Department of Transportation
Technical Services
Roadway Engineering Section
355 Capitol Street NE, Room 222
Salem, OR 97301-3871
Telephone 503-986-3714
FAX 503-986-3749

Addenda No. 2

SUBJECT: Bay Blvd Sidewalk, Lights, & Paving (Newport) Section
SW Bay Boulevard
Lincoln County
(Bids to be opened and read July 16, 2009)

SHEET NO. 2A
TYPICAL ROADWAY SECTIONS

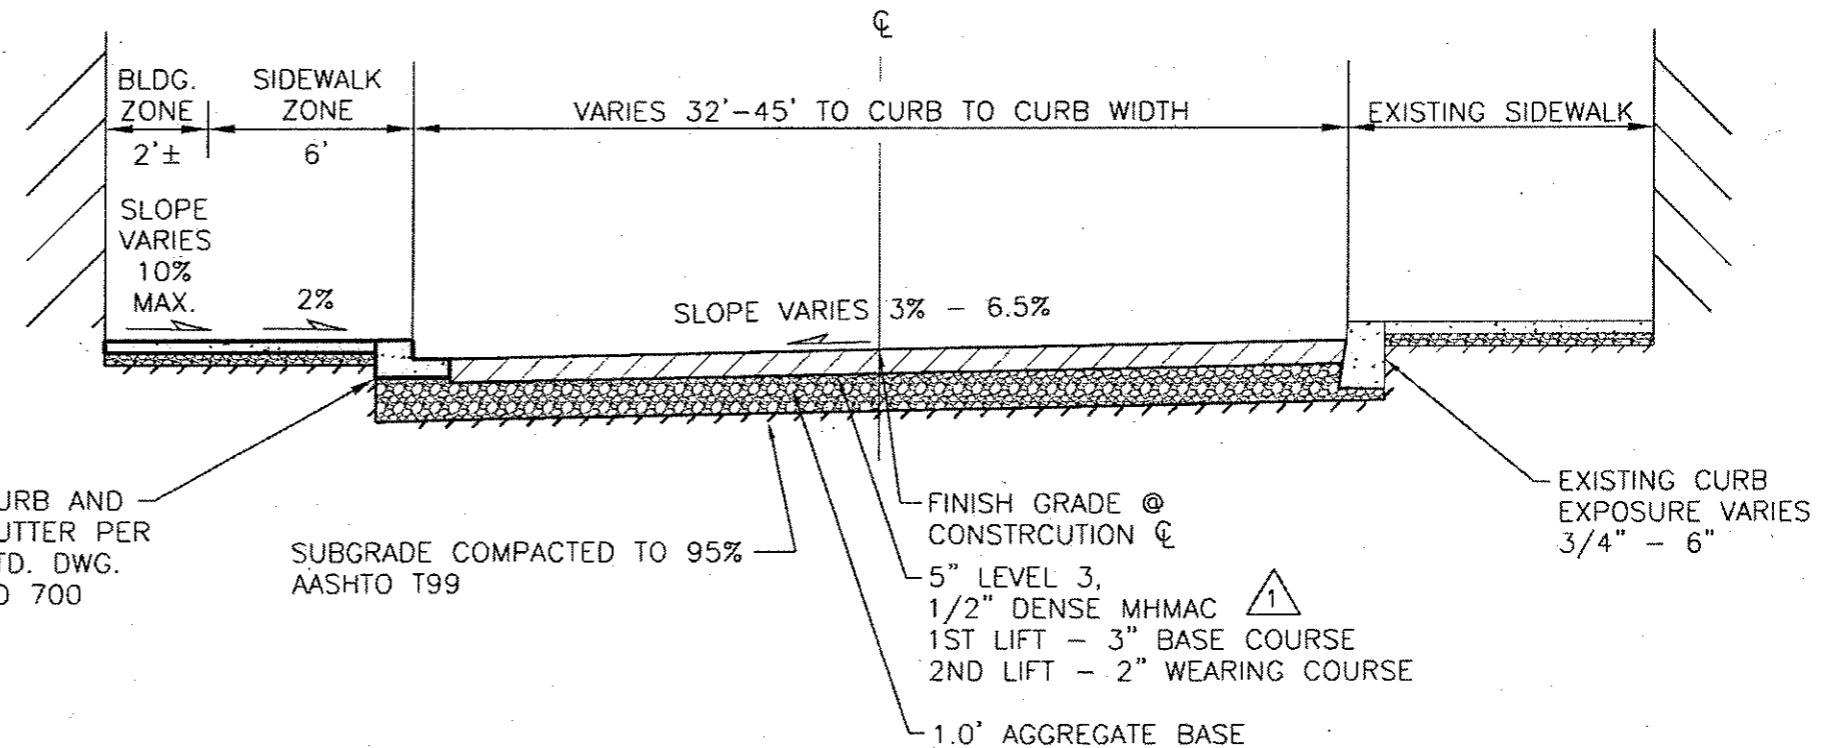
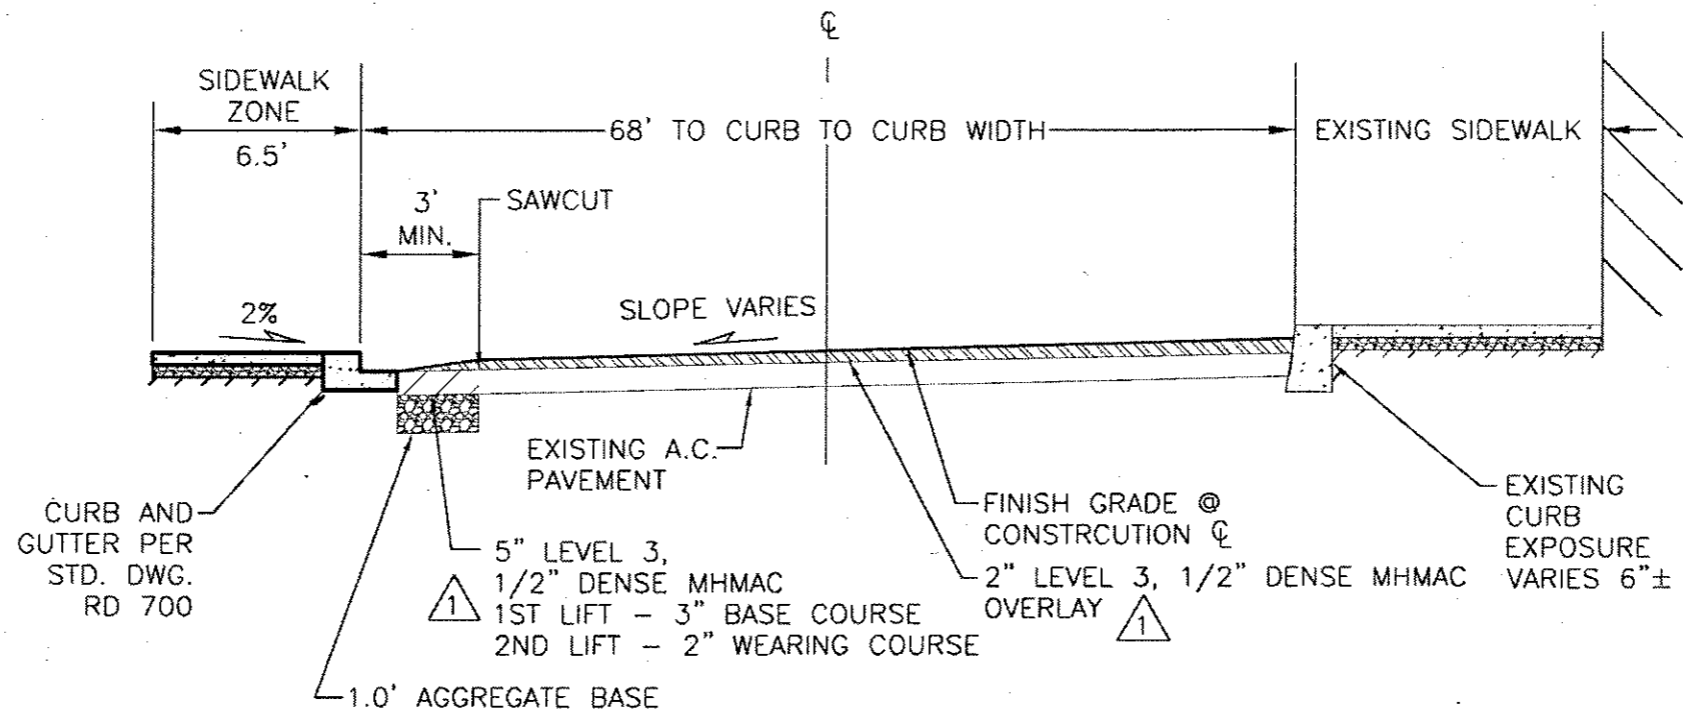
REVISIONS	
1	REVISED 7-8-2009 ASPHALT DEPTH (INCHES) AND LIFT DATA
2

DETAILS SHEET NO. 2B-24

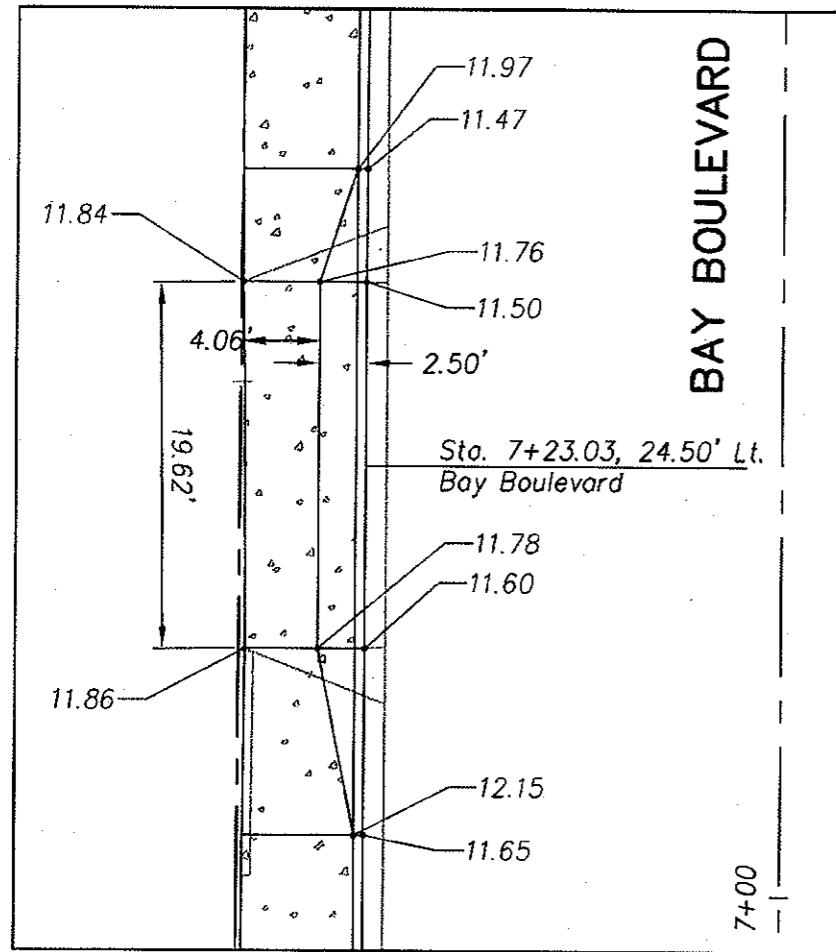
REVISIONS	
△ 1	REVISED 7-8-2009 CONDUIT LENGTHS
△ 2

Driveway #8 1

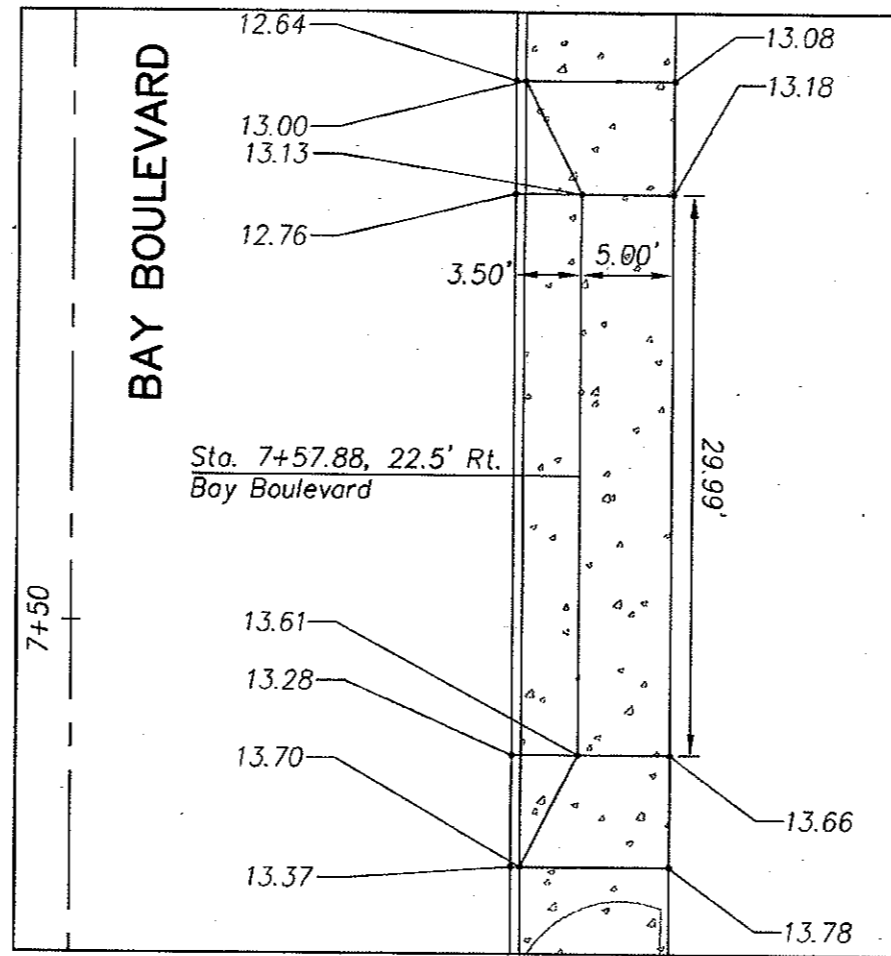
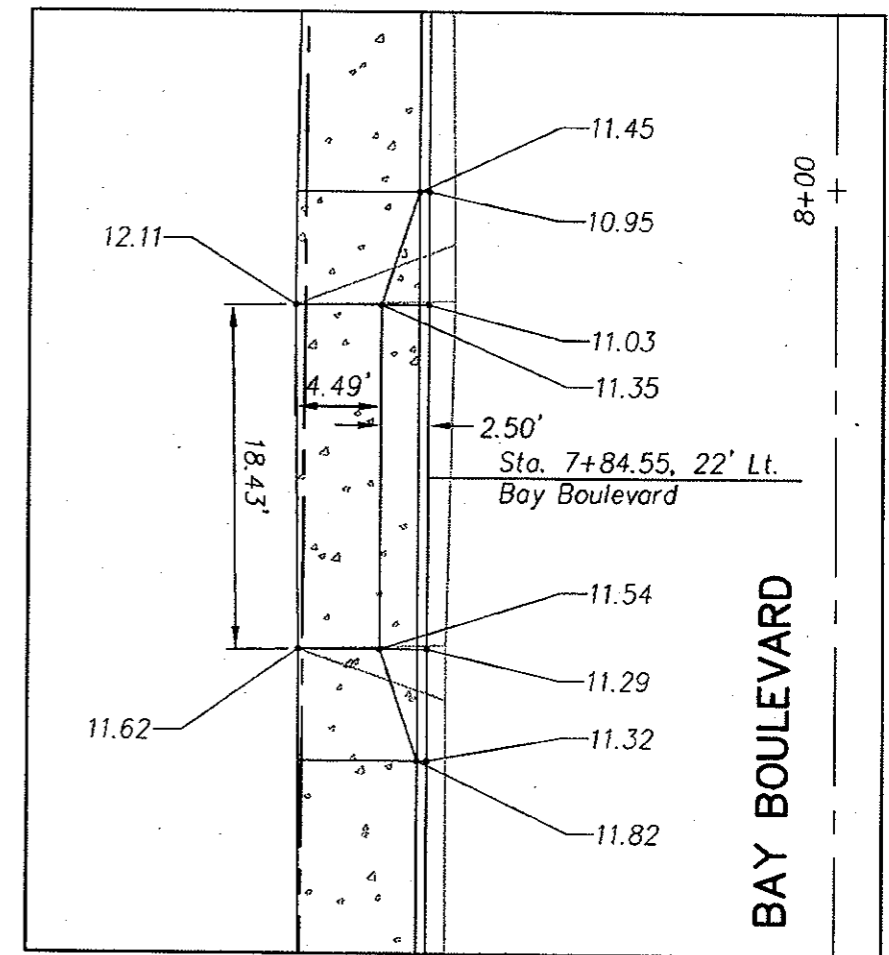
REVISIONS	
1	REVISED 7-8-2009 REVISED GRADES FOR DRIVEWAY #8
2

SHEET NO. 2E-2

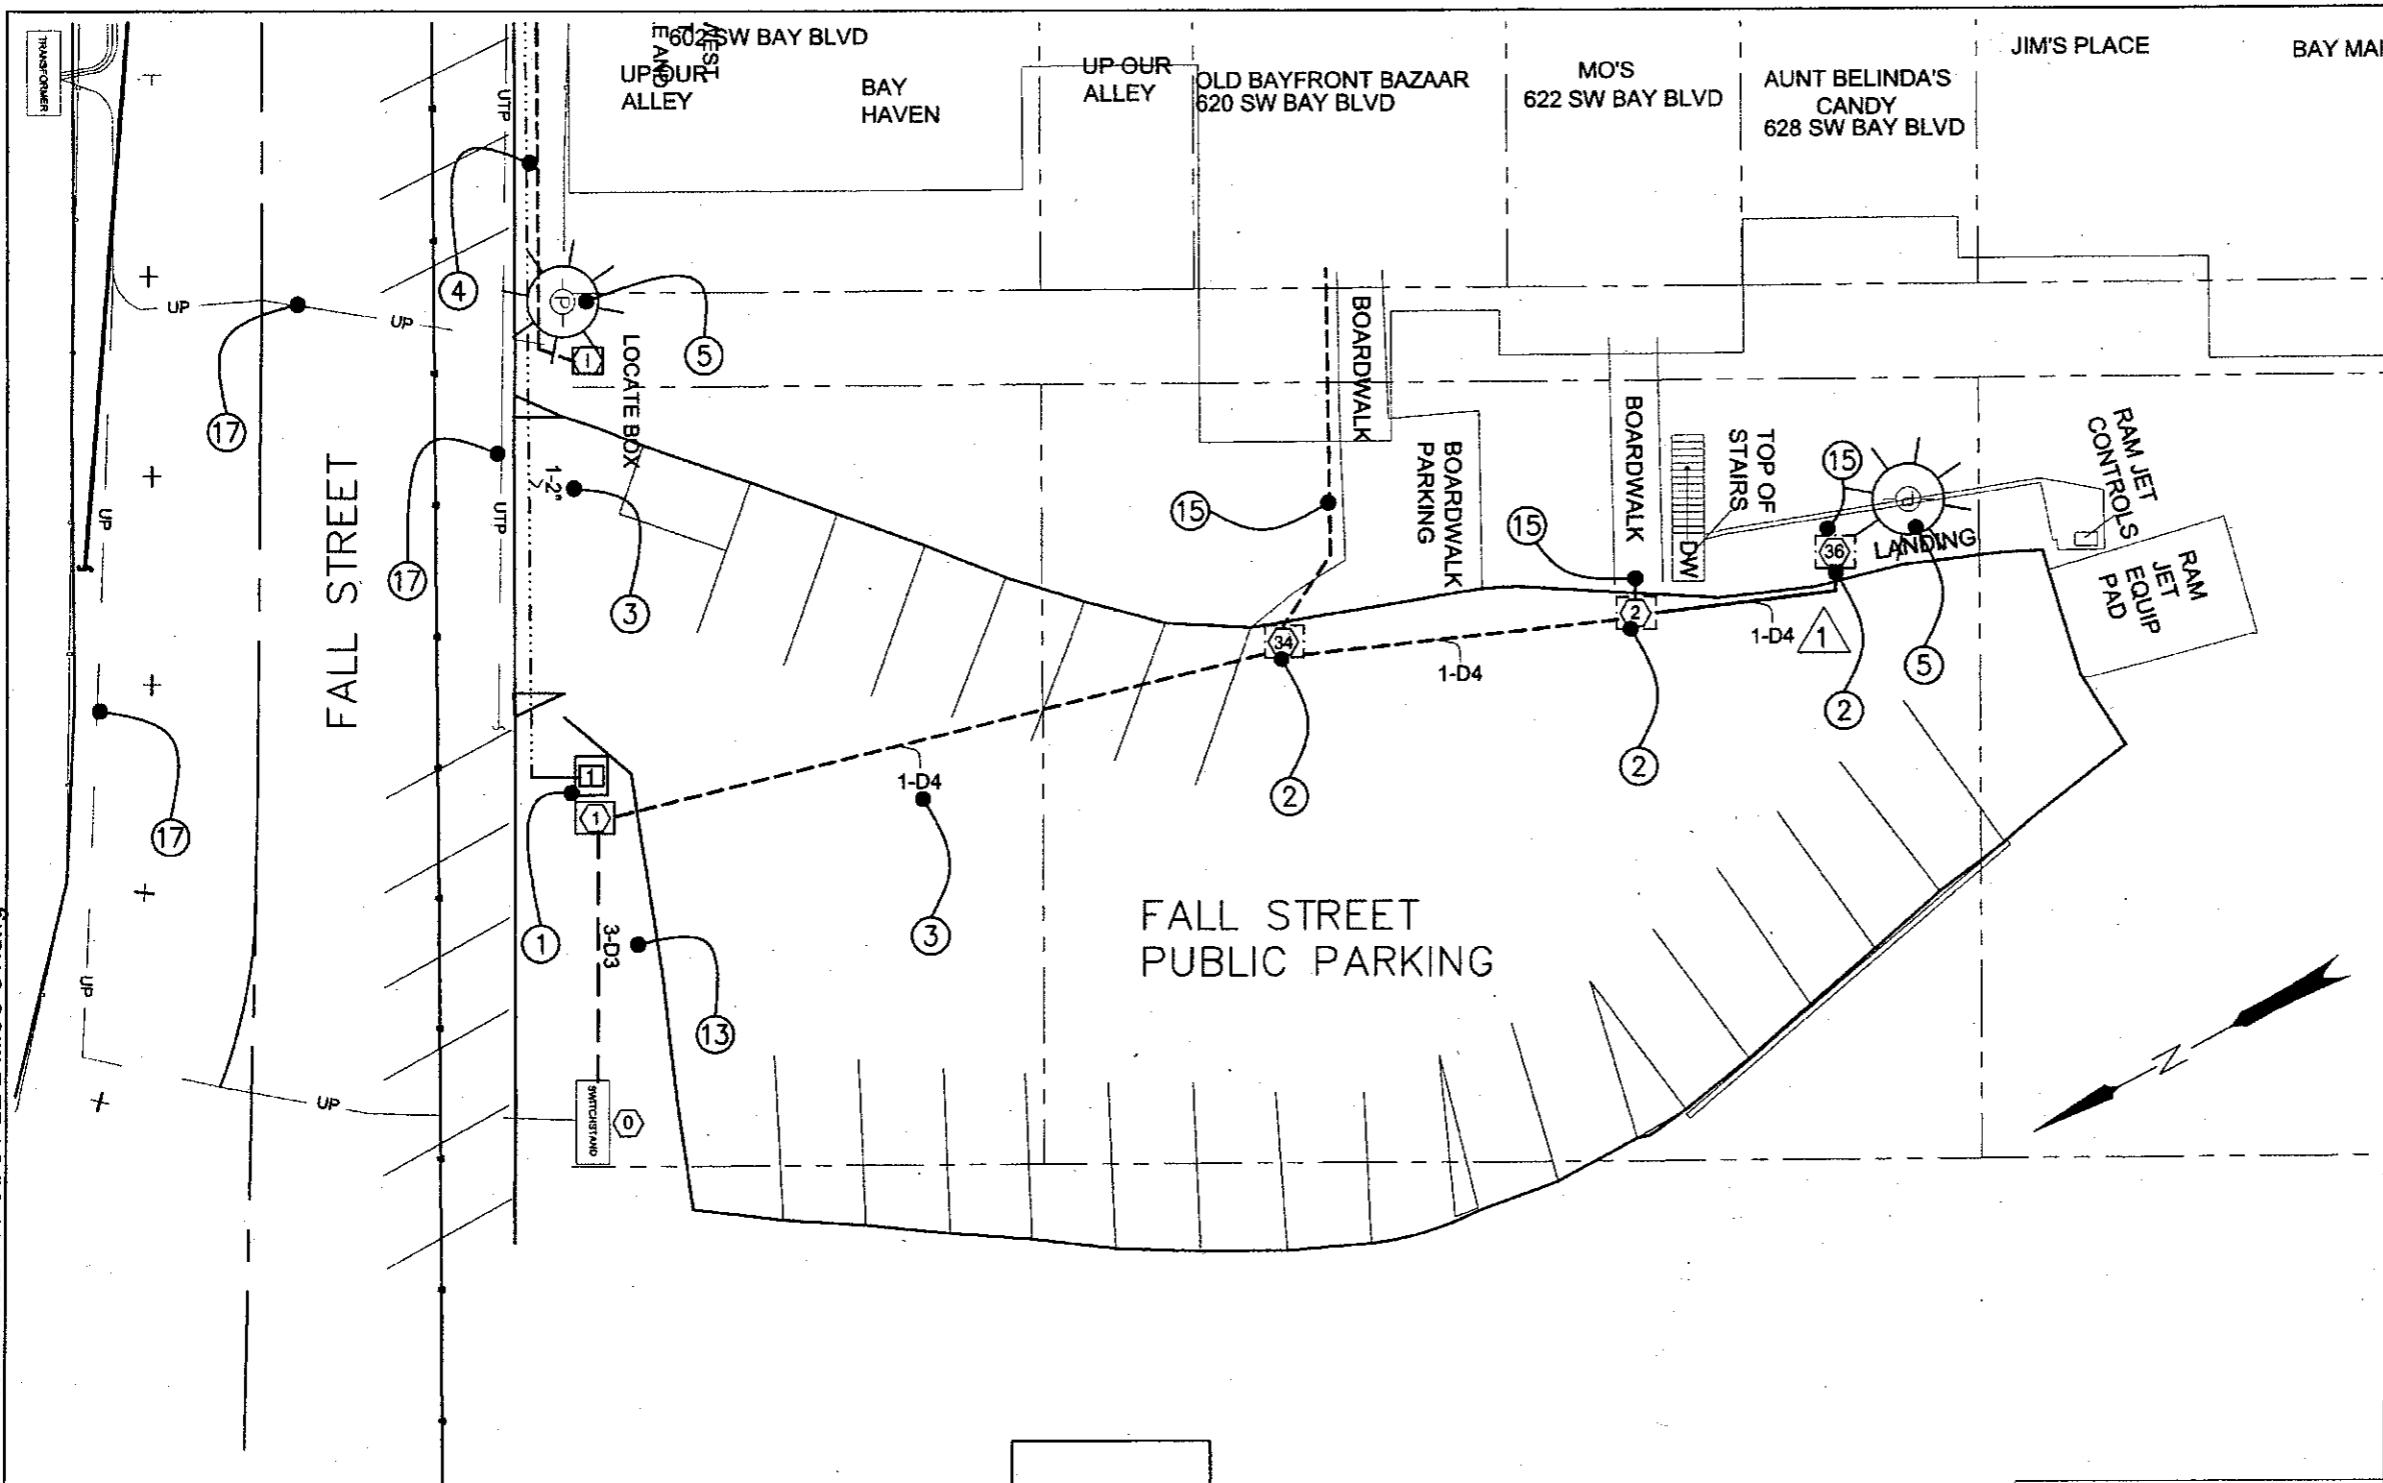
REVISIONS	
①	REVISED 7-8-2009 ADDED VAULT 36 & CONDUIT FROM VAULT 2
②
